# Administrative Approval Action

Case File / Name: ASR-0042-2021  
DSLC - Smith Temple Freewill Baptist Church

**REQUEST:** Development of a 3.16 acre/137,650 sf tract zoned R-4 with an existing single-family dwelling unit (to be demolished) for a proposed Civic Use, place of worship totaling 9,766 sf with associated vehicular parking.

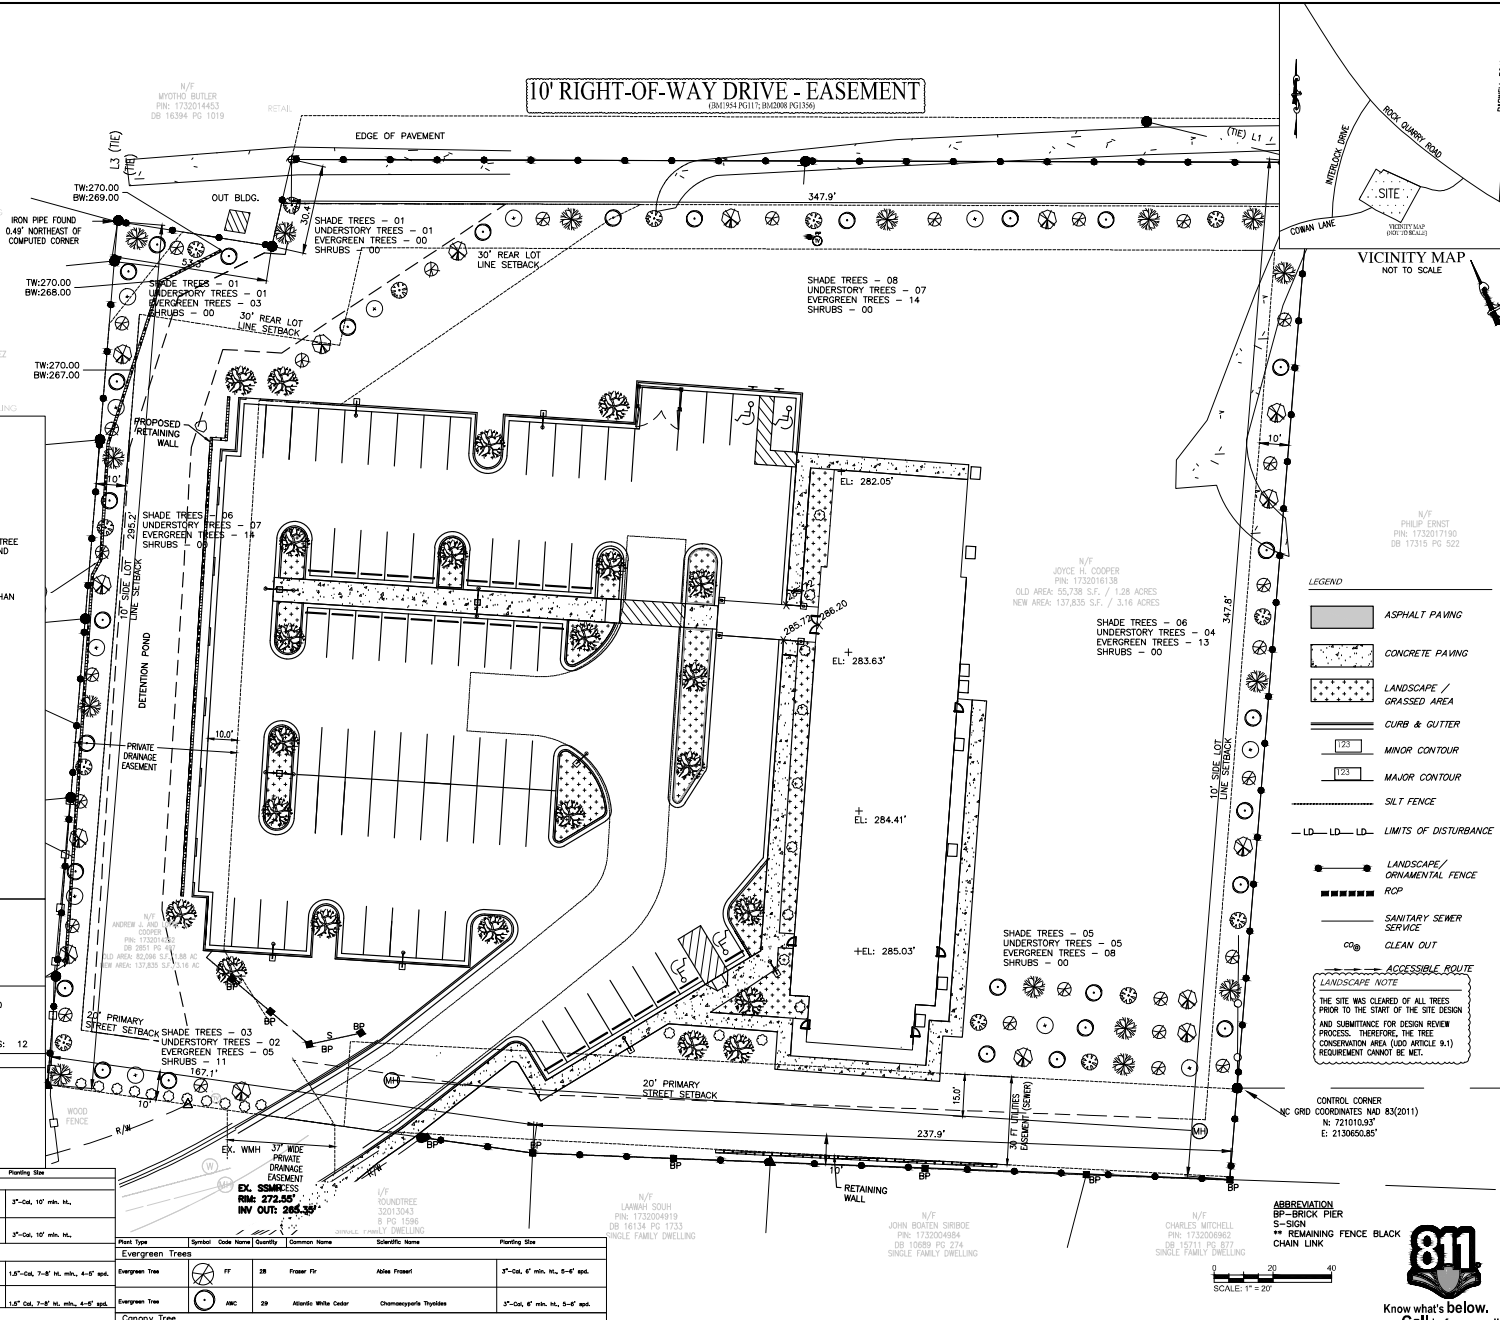
4. Landscaping sheet C400 planting schedule and tree information is revised removing the 'canopy' and 'evergreen' references from the site and tree summary table. SPR plans & landscaping table must be revised to show and demonstrate compliance with tree type design & installation requirements as listed in UDO Sec.7.2.7.C.

8. Landscaping sheet C400 (of the ASR plans set) is revised according to the Use Standard requirements for a Civic Use for the Transitional Protective A2 Protective Yard buffer per UDO Sec.6.3.1.E & Sec.7.2.4.D. Quantities do not match the LF and calculations along property lines.

10. Applicant clarifies the proposed fence screening shown on sheet C400 & C700 for the Transitional Protective Yard buffers shown on sheet C400. And demonstrate design compliance with UDO Sec.7.2.4.D.

12. Required landscaping plantings, on sheet C400, are reviewed and approved by Stormwater Division, for the transitional protective yard buffers placement and location and the private drainage easement.

15. Please remove proposed trees from the CORSSE. There shall be no landscaping within sanitary sewer easements.

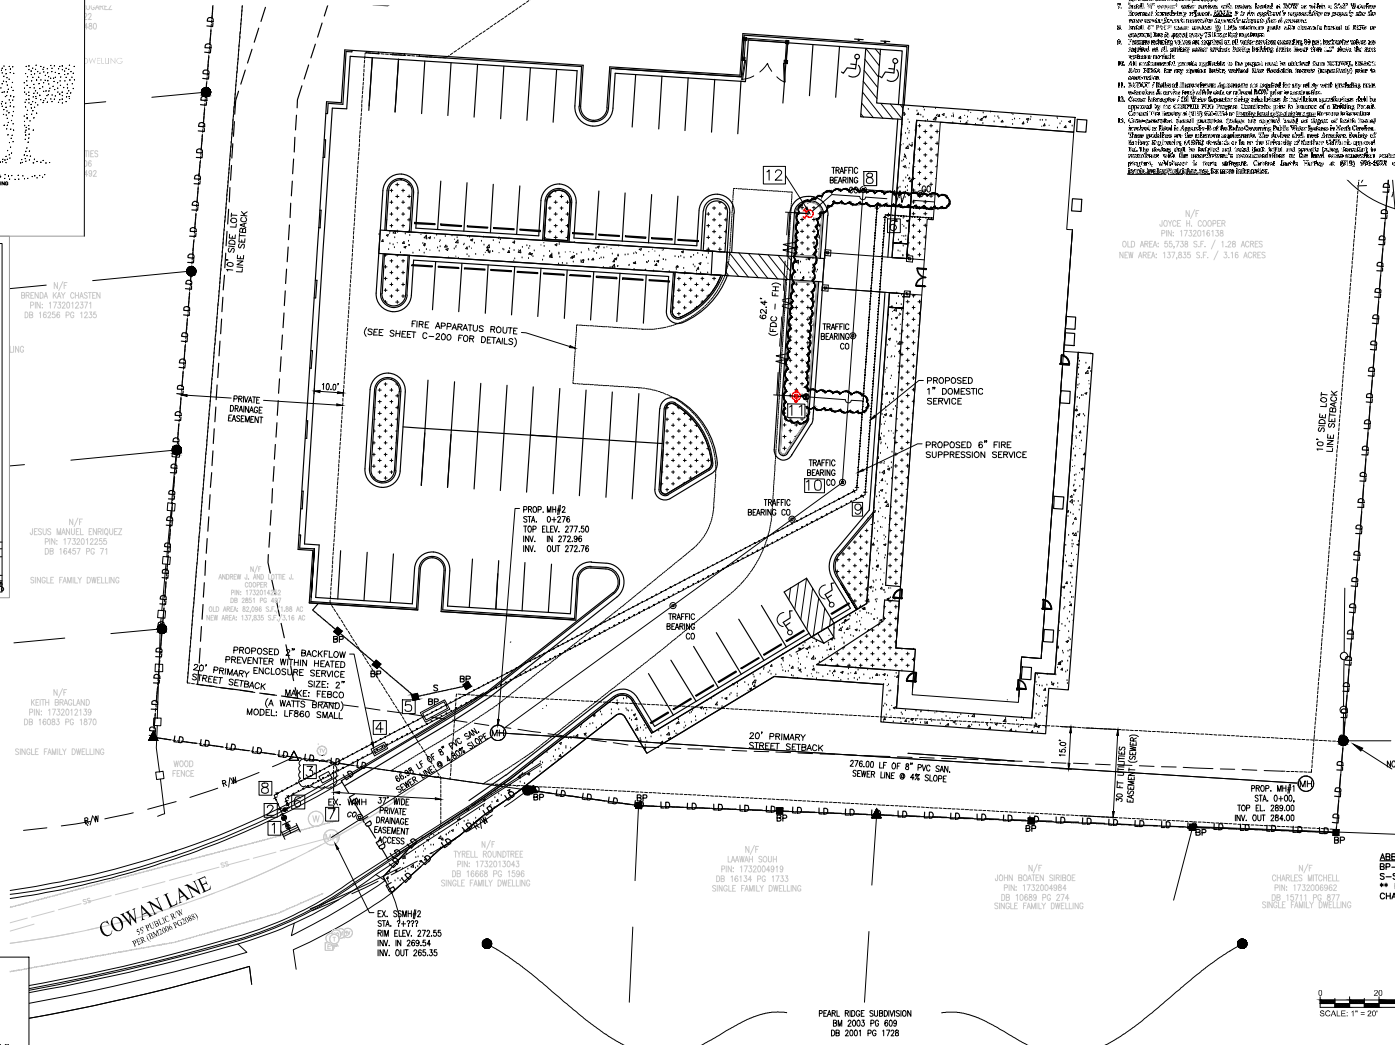
2. There shall be no trees within the proposed 30' CORSSE.
  3. There shall be no light fixtures within the proposed 30' CORSSE.
  4. There shall be no fire hydrant within the proposed 30' CORSSE.

5. The proposed 30' CORSSE does not fully encompass the entire sewer main extension near the property line. The initial sewer cleanout is not necessary with the extension of the sewer main. There should be a cleanout at the easement line leading to your property and thereafter. Feel free to call or email Cydney Terry to discuss.

6. There is a proposed storm pipe running parallel within the proposed 30' CORSSE and that is prohibited.
  7. There is a proposed storm pipe directly over the proposed sewer manhole and that is prohibited.

8. Please confirm the use of the proposed retaining wall that appears to be running parallel inside of the proposed 30' CORSSE, which is prohibited. If it is to be adjacent to the CORSSE, please demonstrate that it will not impact the ability of CORPUD to access and maintain the proposed 8" sewer main.

RIGHT (SOUTH) ELEVATION  
SCALE: 1/8"=1'-0"

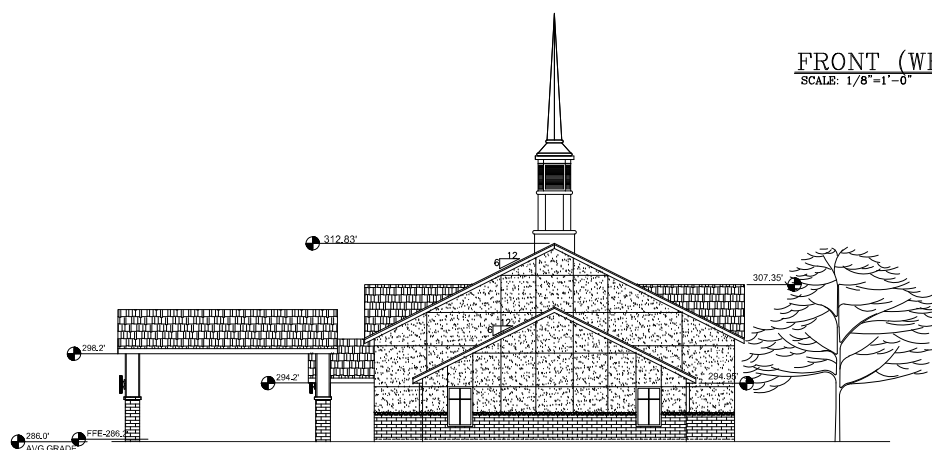
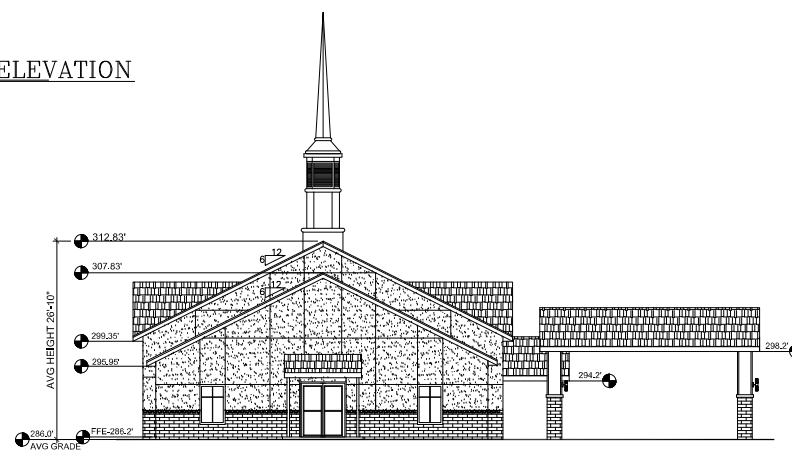
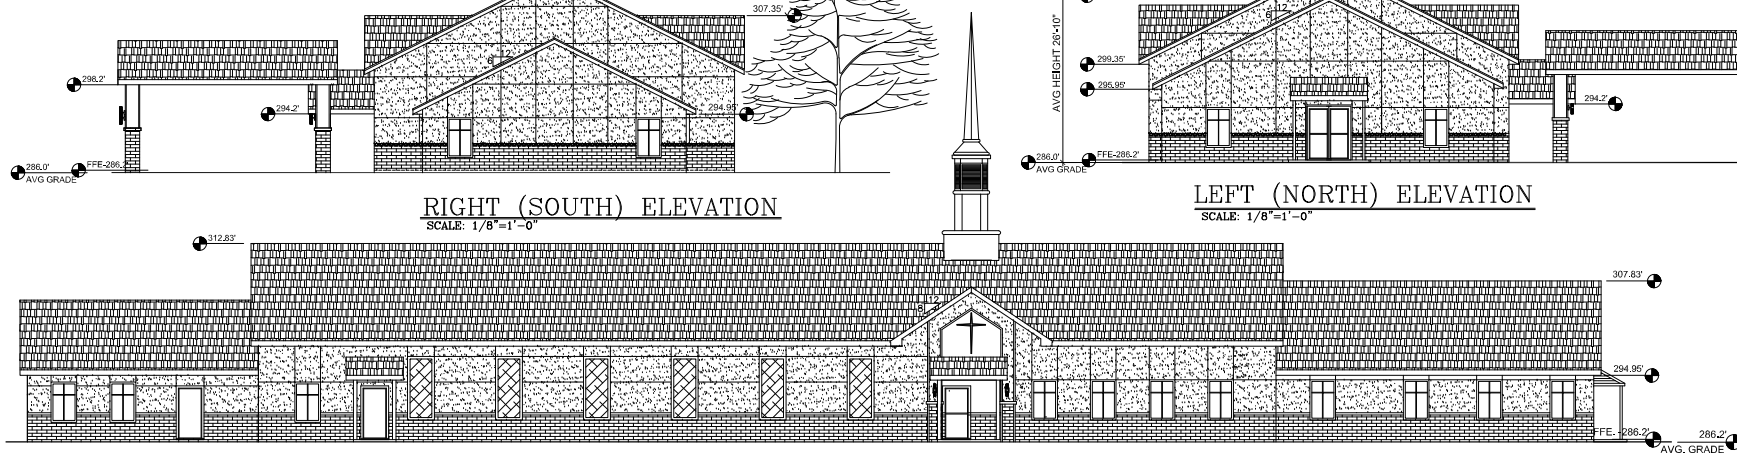
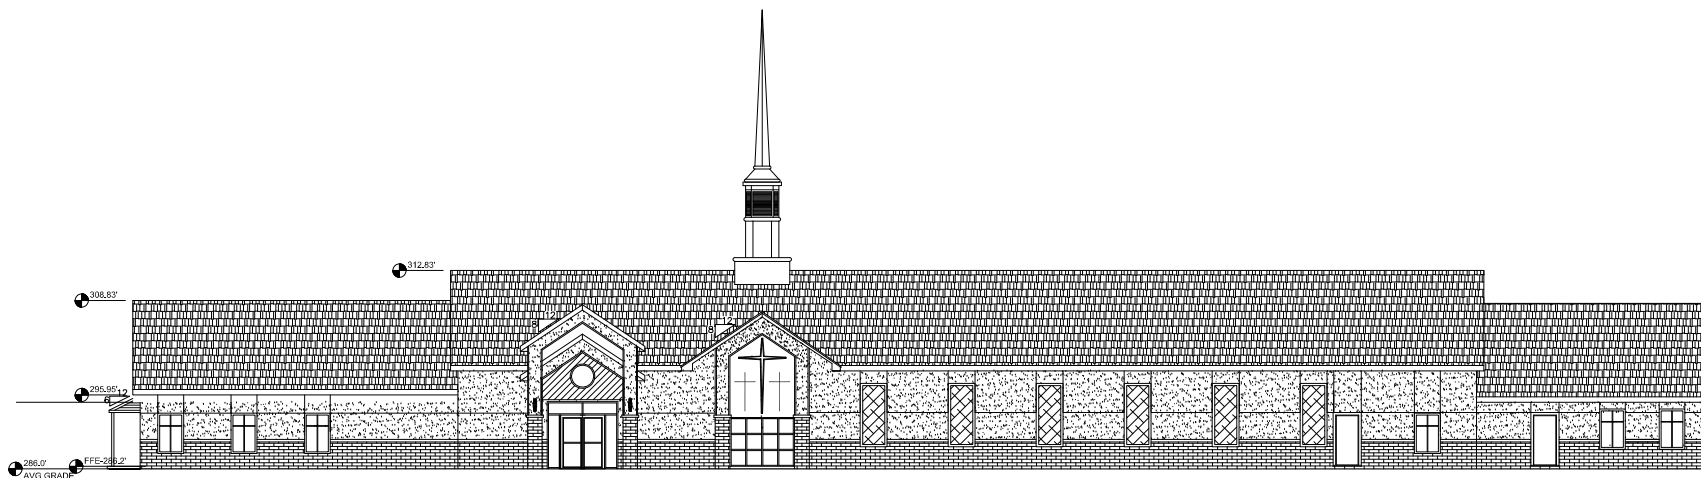
1. Elevation sheet T11, the post-development spot grades are shown on the south elevation rendering & demonstrate compliance with Sec.1.5.7.A and TC-4-20 and those spot grades (high, low & avg) are also spotted on the footprint on page C300 (Grading Sheet).

11. Elevation sheet T11 is revised, updated & shows the delineated floor-to-floor height dimensions for the proposed 2nd story and demonstrate compliance with UDO Sec.1.5.7.C.
